SERVICE BULLETIN

APPLICABILITY: 2013-14MY BRZ

NUMBER: 12-160-13

SUBJECT: Cracked Rear Combination Lamps

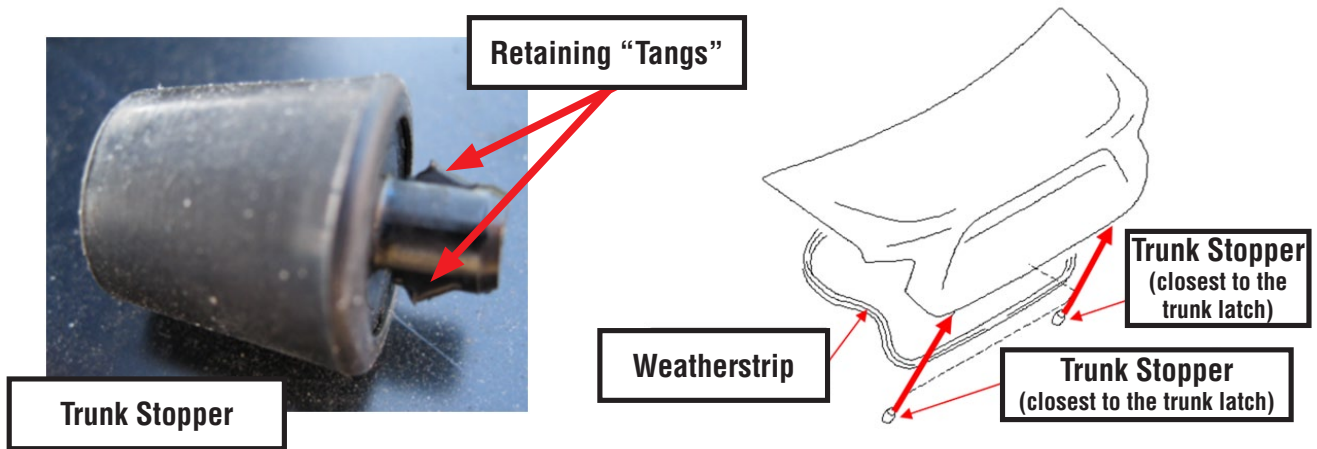
A liner was added into the weatherstrip for increased resistance to crush and the trunk stopper's overall height was increased by 2.7mm to minimize the chance of trunk lid contact with the combination lamps.

PART NAME	PART NUMBER
WSTR Trunk	57532CA001
Stopper Trunk Lower	57533FE040
